Dynamic Site Investigation Former Operational Areas B, C, F, G, and H Lockheed Martin Corporation, Beaumont Site 1 Beaumont, California

RESPONSES TO DTSC COMMENTS ON THE DYNAMIC SITE INVESTIGATION REPORT
LOCKHEED MARTIN CORPORATION, BEAUMONT SITE 1, BEAUMONT, CALIFORNIA
TETRA TECH, INC
REVISED SEPTEMBER 2009

Figure 3-5 (cont.)
Cross Section
Location Map

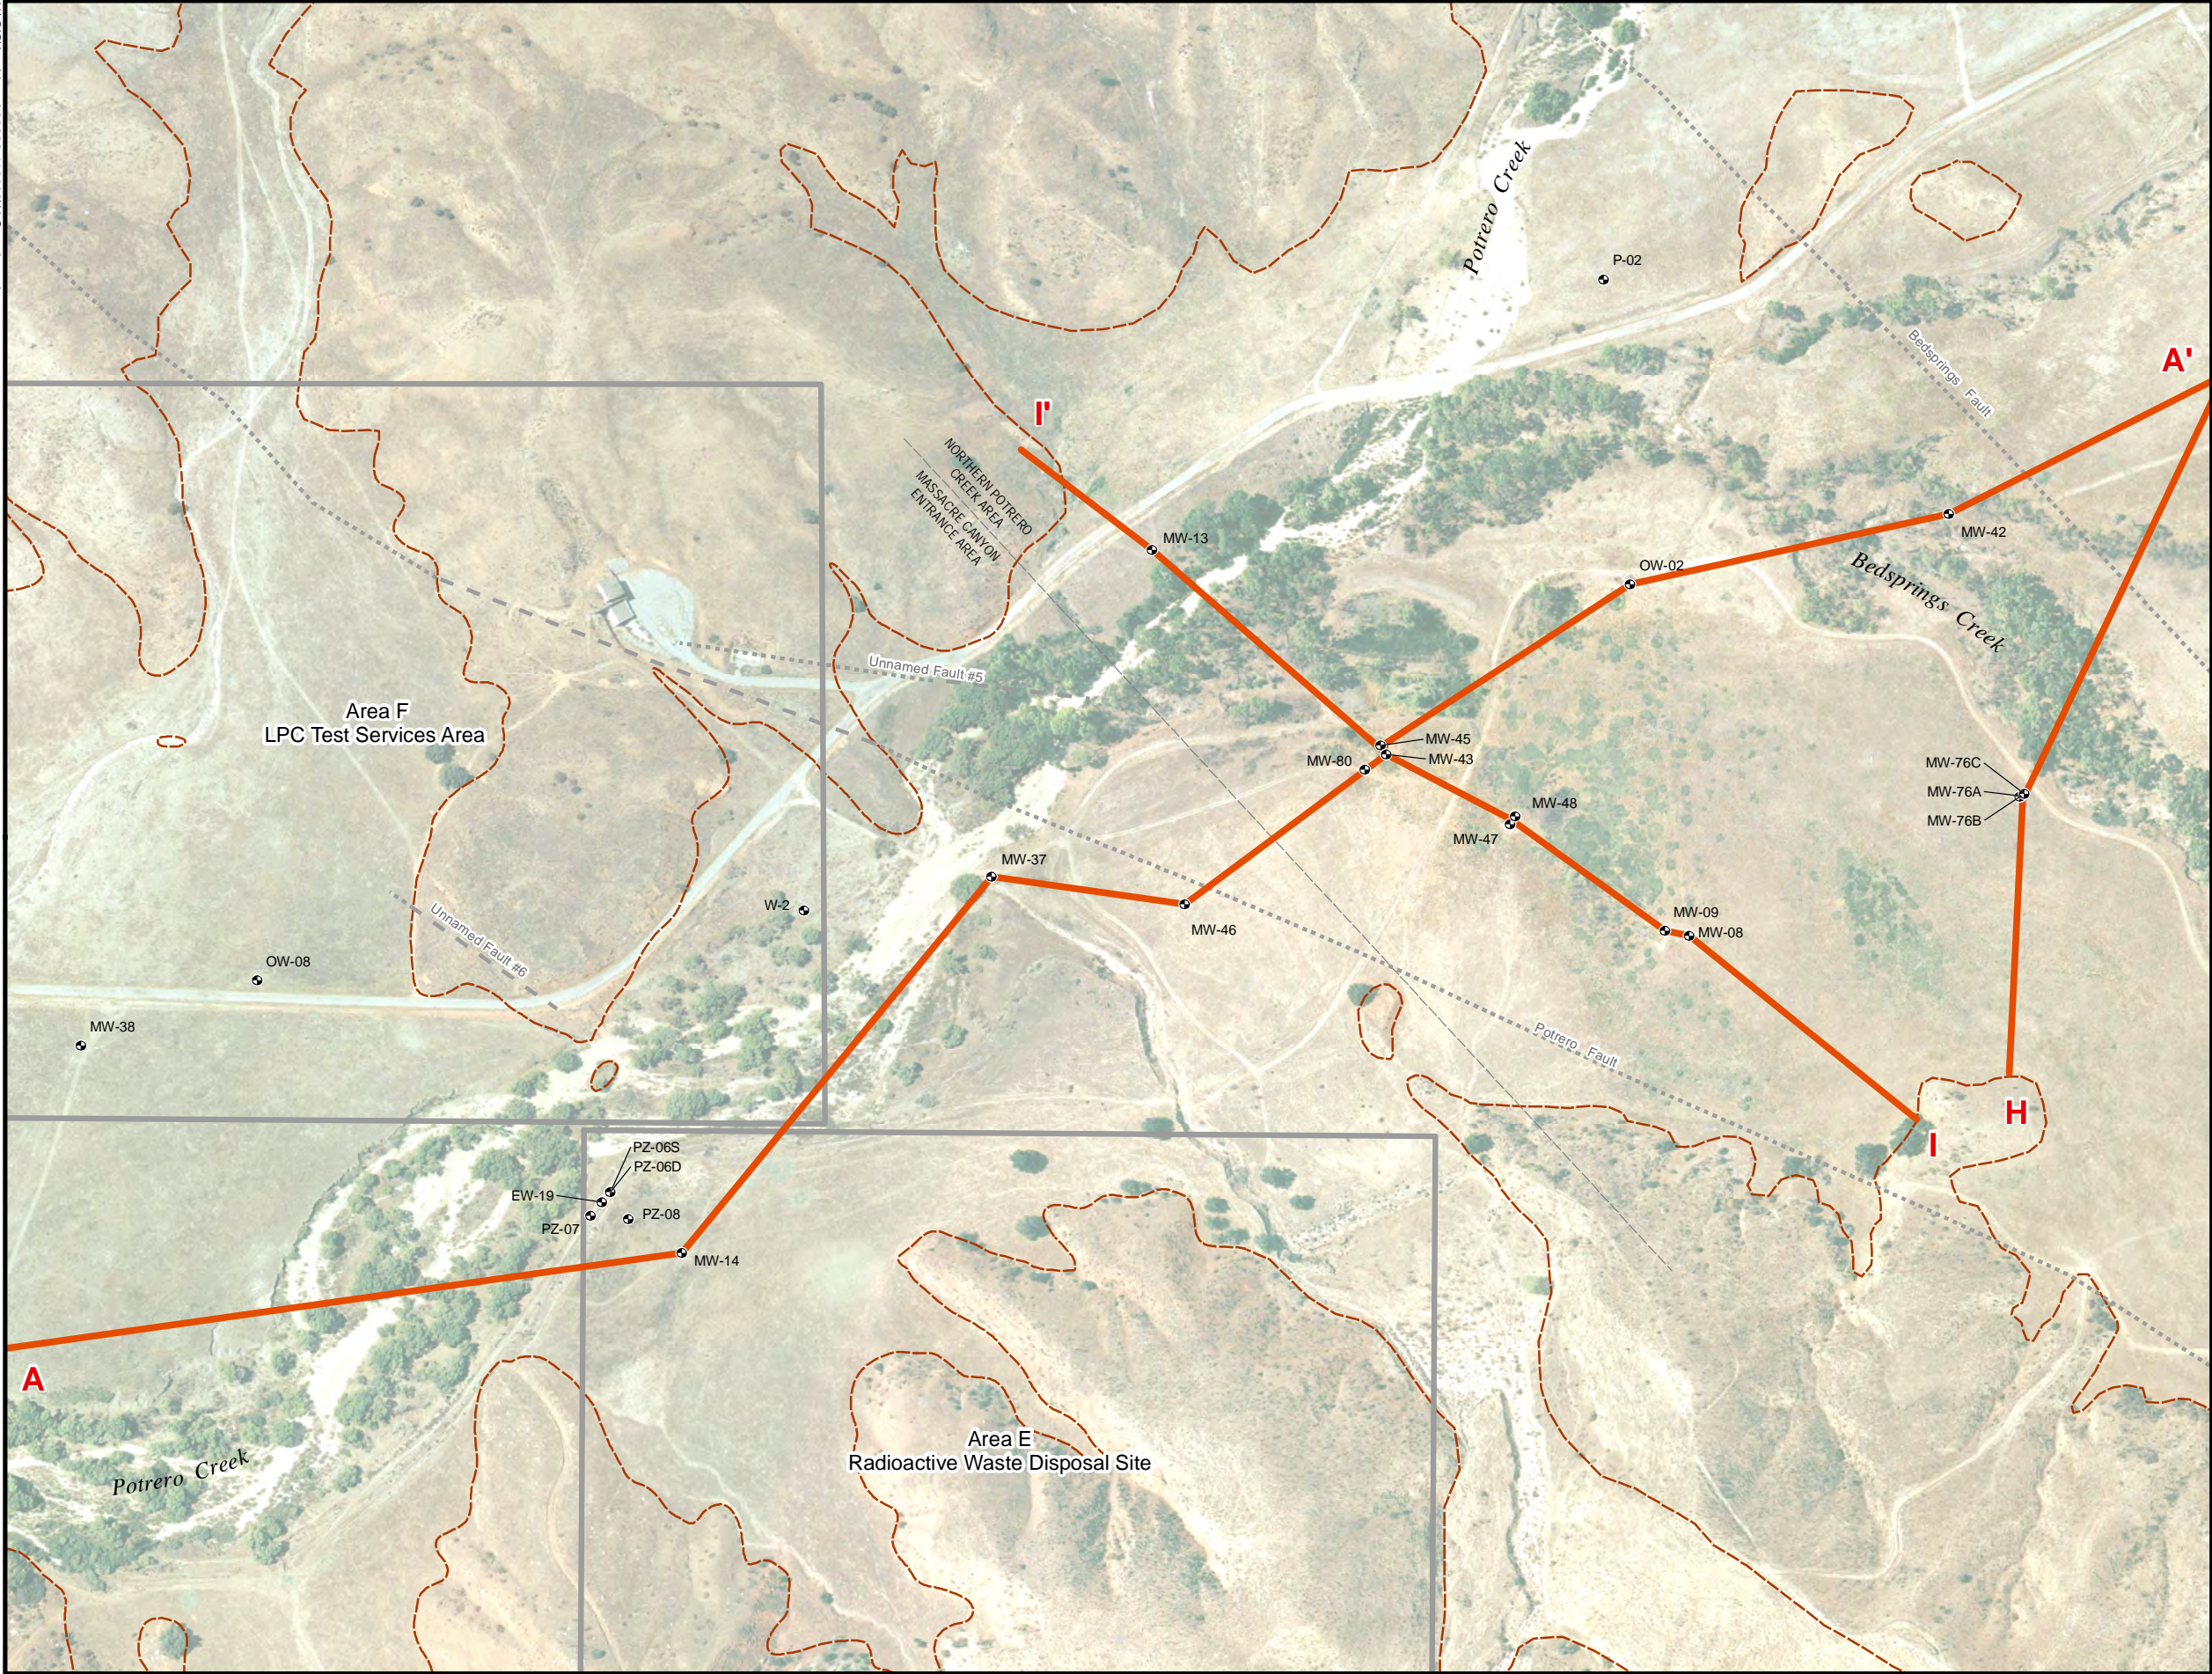
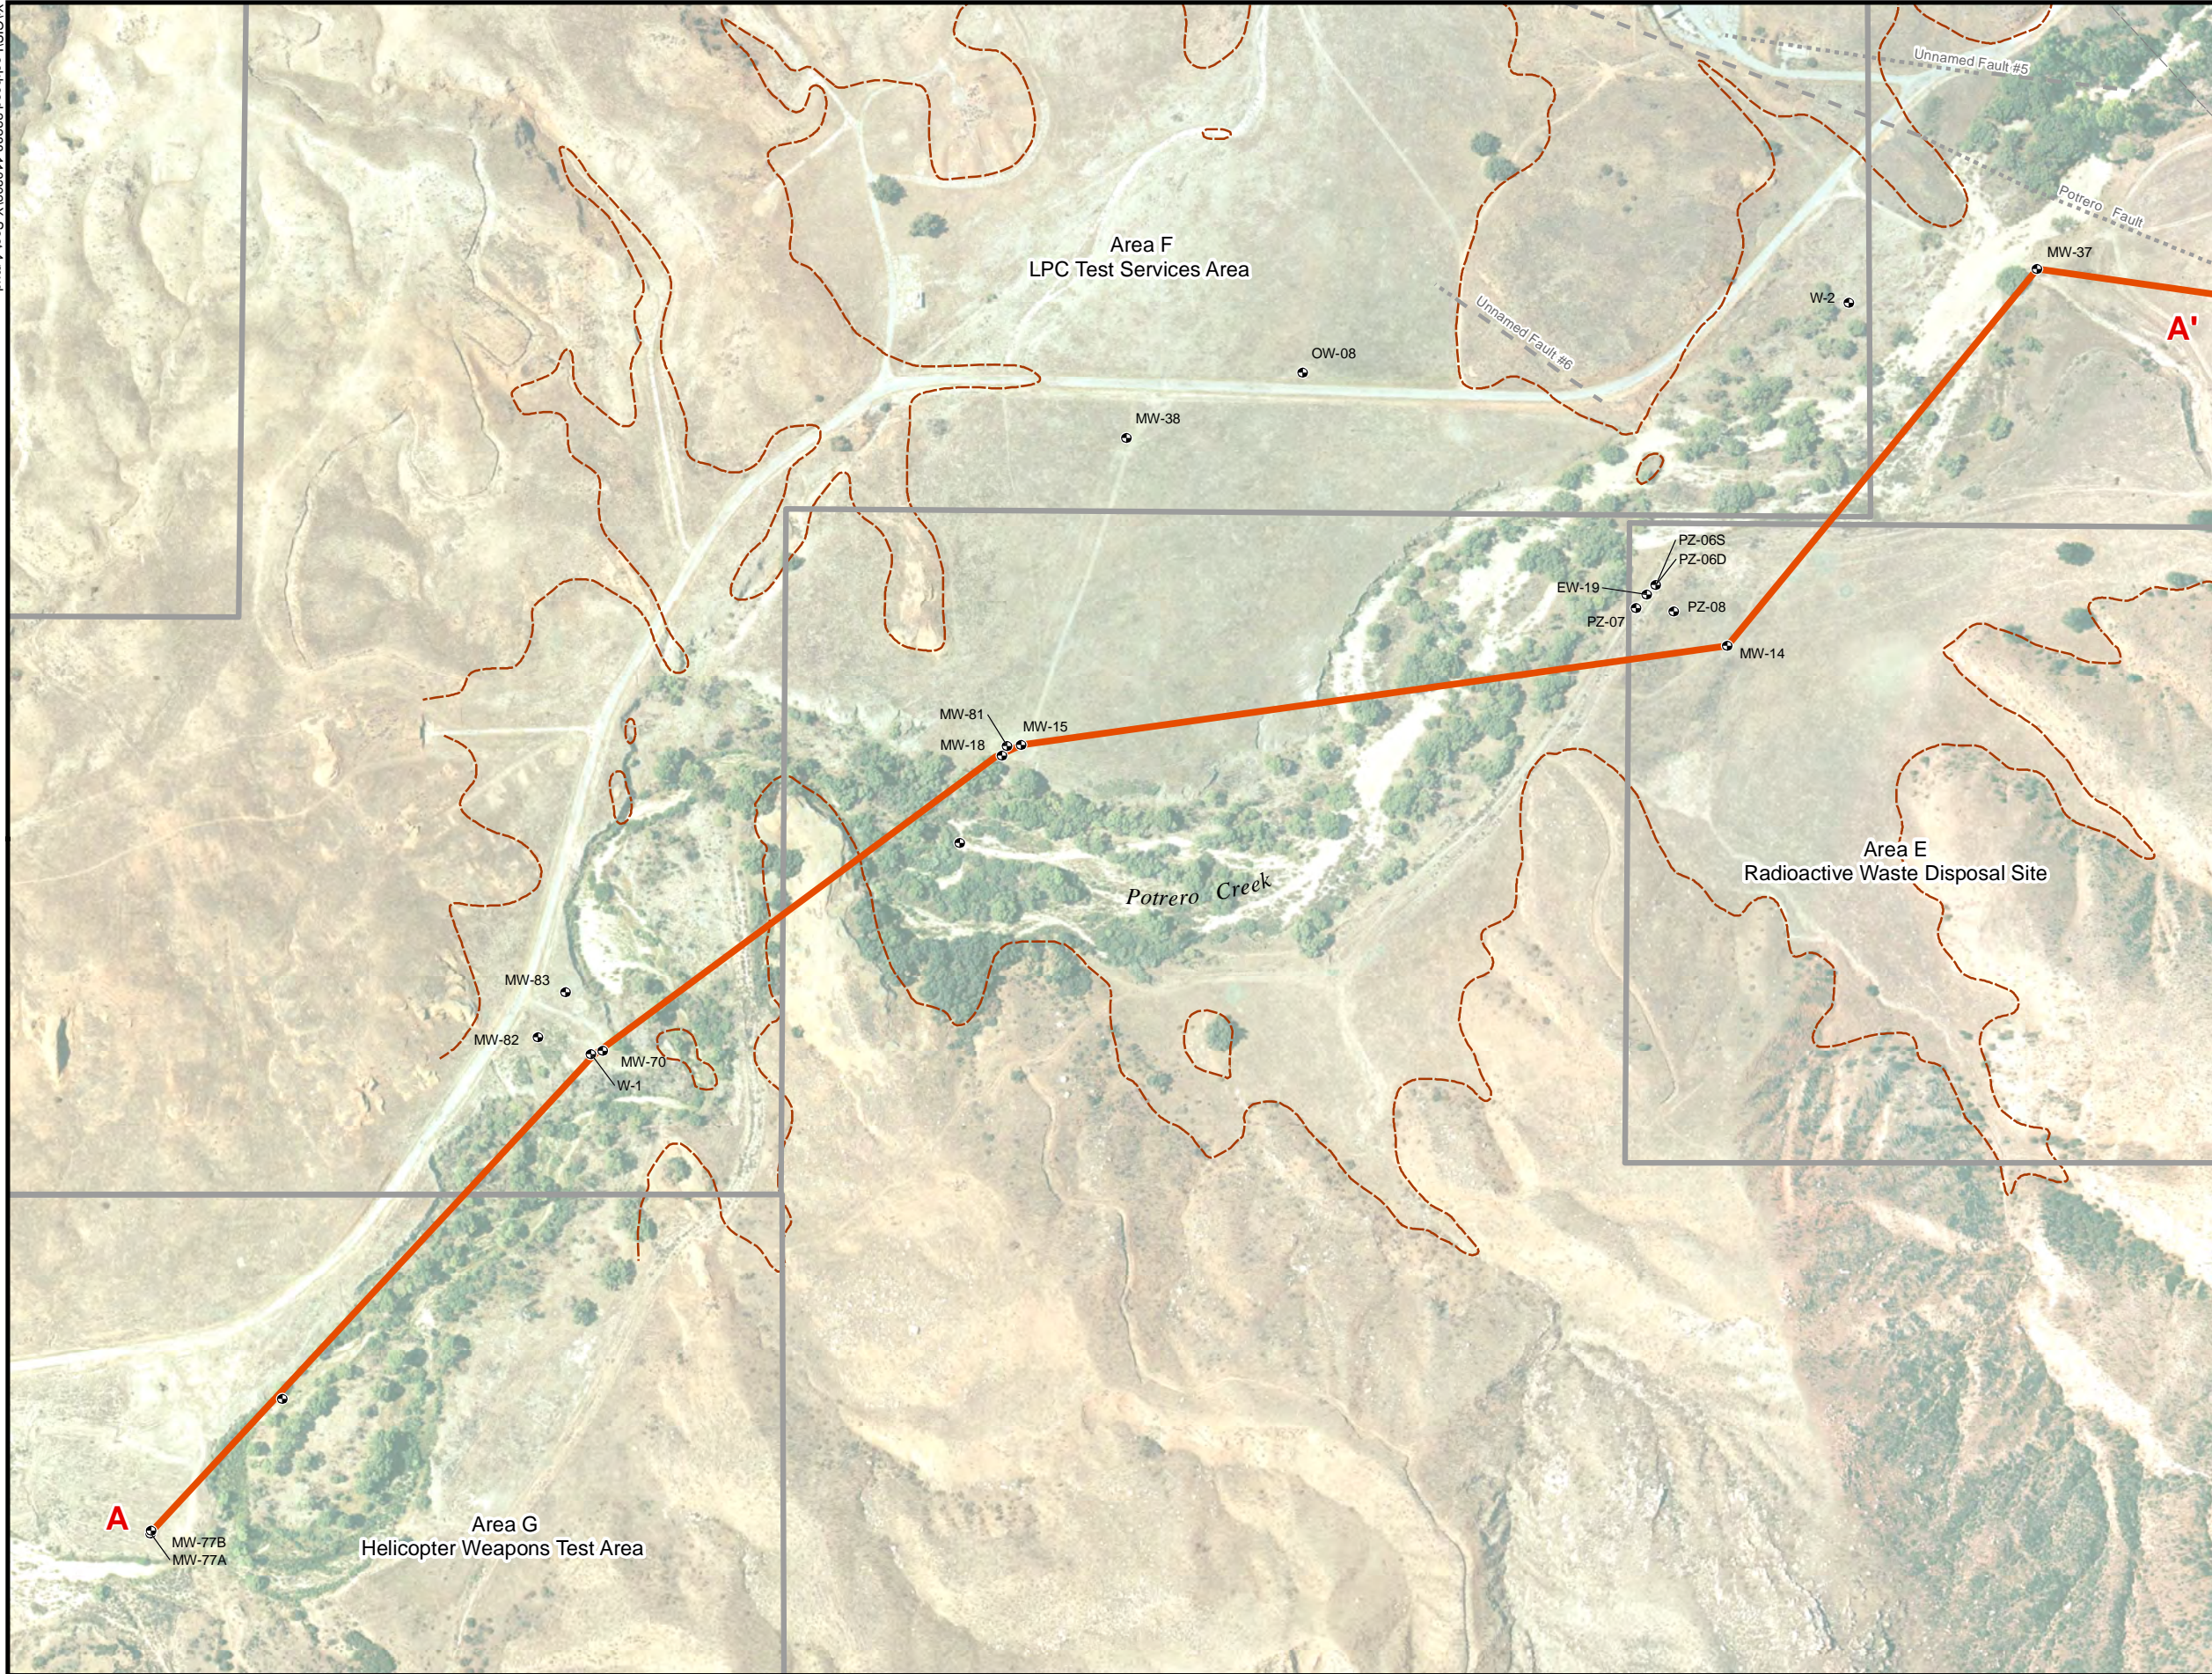
Comment	Response	Proposed Action
1. Figure 3-5 (cont, from MW-14 to MW-42): This cross-section trace, A-A' should be labeled (even though the ends are outside the boundaries of the figure).		The requested change will be made to Figure 3-5.
